Type 3/4 PSEs Inrush_max value with Type 1/2 PDs

IEEE802.3bt

Rev 005

Yair Darshan

Figure 33–13— $I_{Inrush-2P}$ current and timing limits, per pairset in POWER_UP

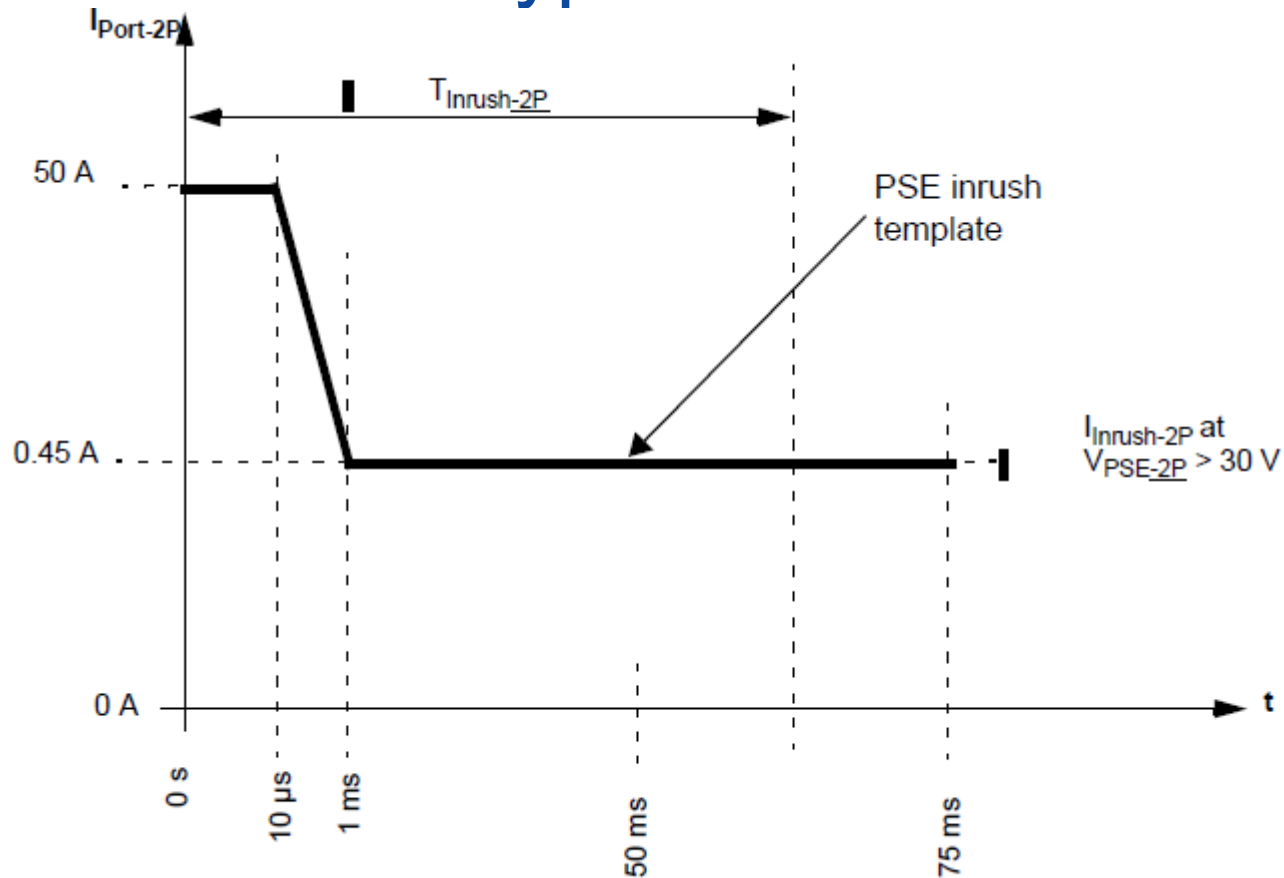
(1) 50A. $\rightarrow I^2 \cdot t = 2500A^2 \cdot t$! (The Fusing Energy). It is $\gg 0.45A^2 \cdot t$ for the 50A area.
 ~5000 times higher !

(2) Inrush Energy = $49\text{msec} \cdot 57V \cdot 0.45A + \approx \int_0^{1\text{msec}} 57V \cdot t \cdot i(t) dt > 0.63\text{Joule}$

Type 3/4 PSE connected to Type 1/2 PD

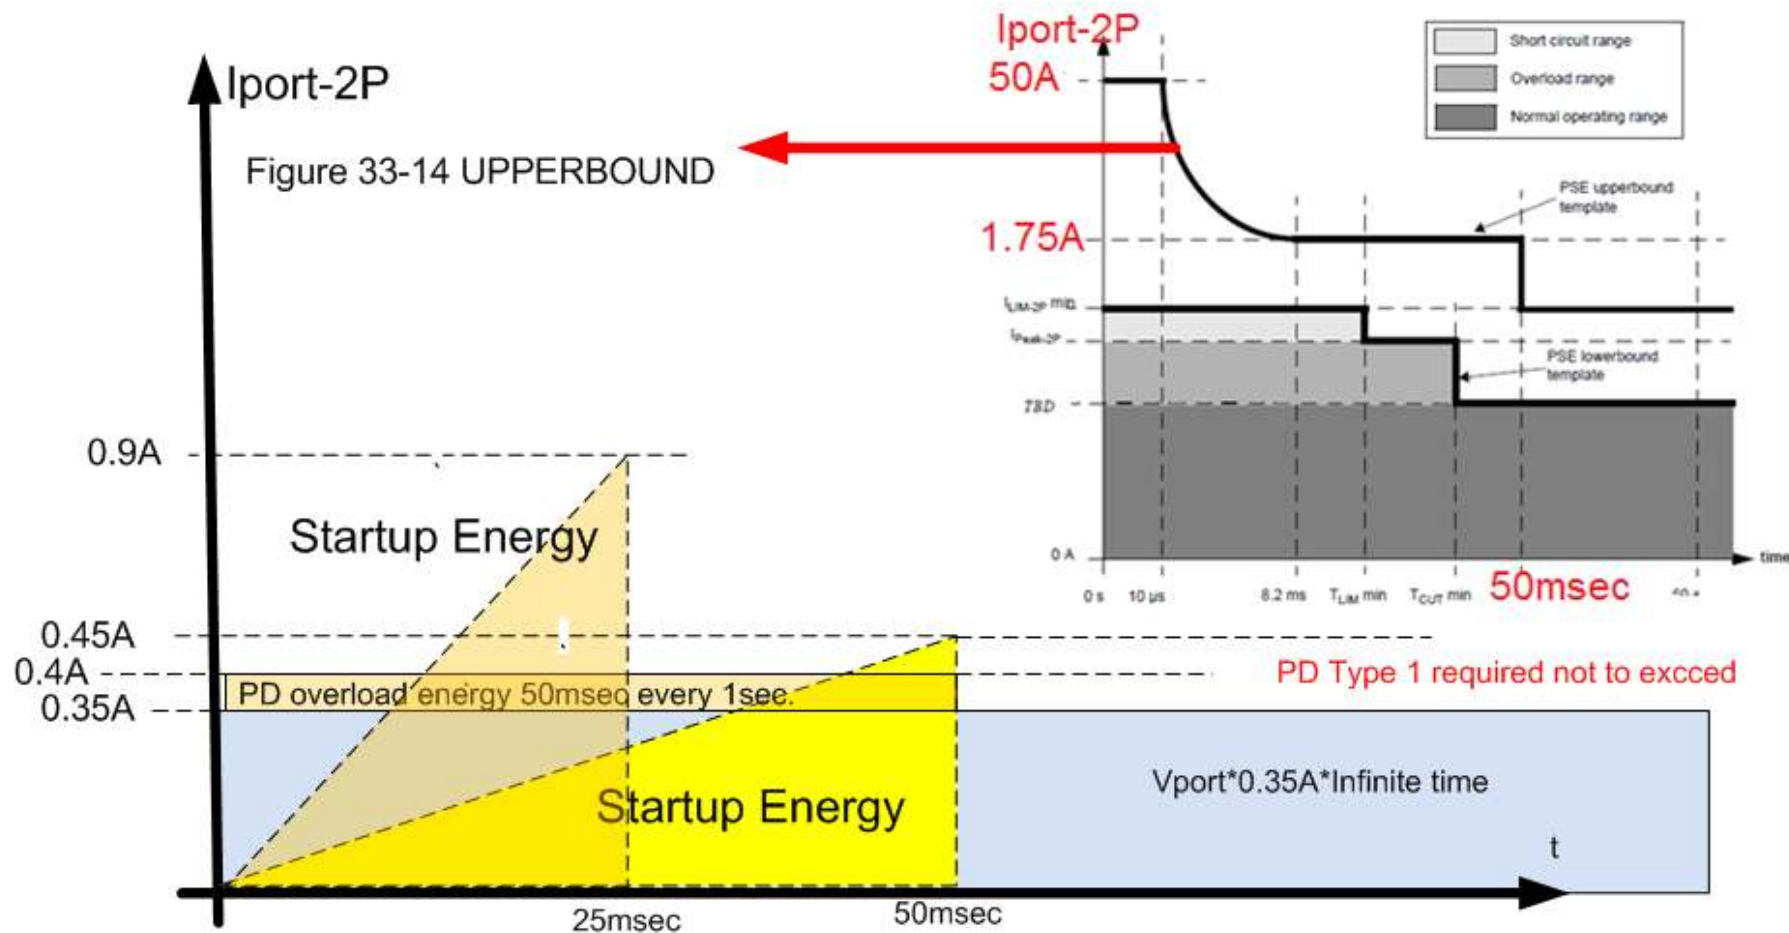
- Same Energy or lower if Inrush increased from 0.45A to 0.9A ignoring the 50A part....:
- Needs to meet PSE upperbound >> 0.45A (1.75A/50msec, and 50A/10usec → 1msec).

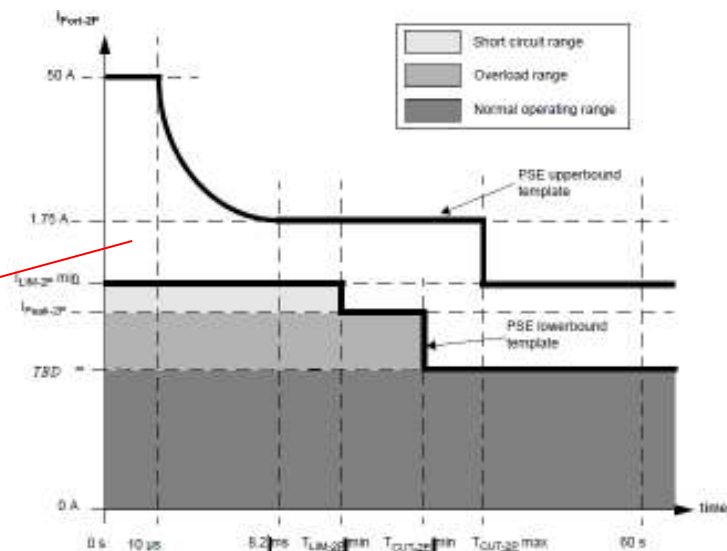
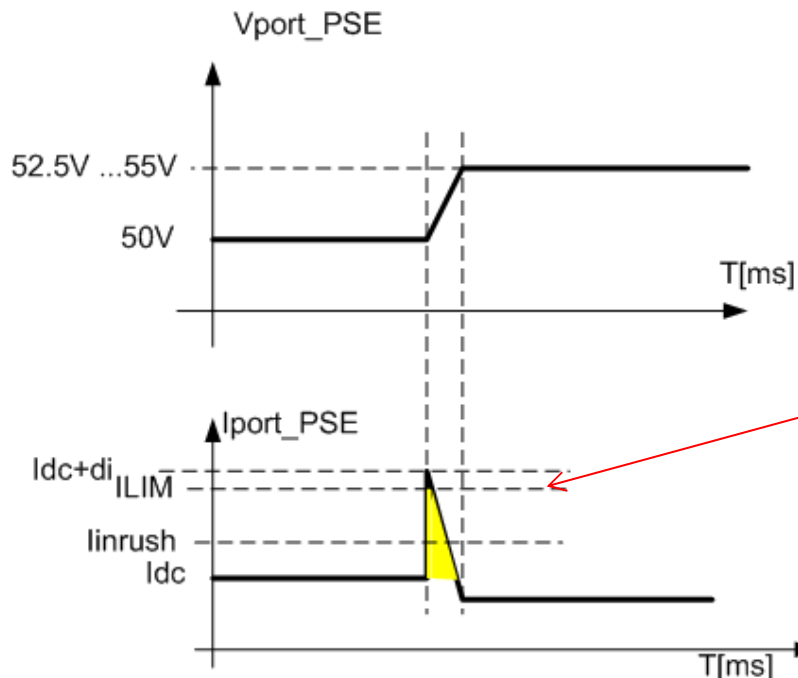
- PSE can limit up to UPPERBOUND template. PD sees I_{inrush} like $>> I_{port}$

$I_{peak} = I_{dc} + 180\mu F \cdot 5V / 0.5\text{msec} = (I_{dc} + 1.8A) > I_{inrush} = 0.45A \text{ max}$
Actual I_{peak} is limited by I_{LIM} which can be anything up to upper bound template.
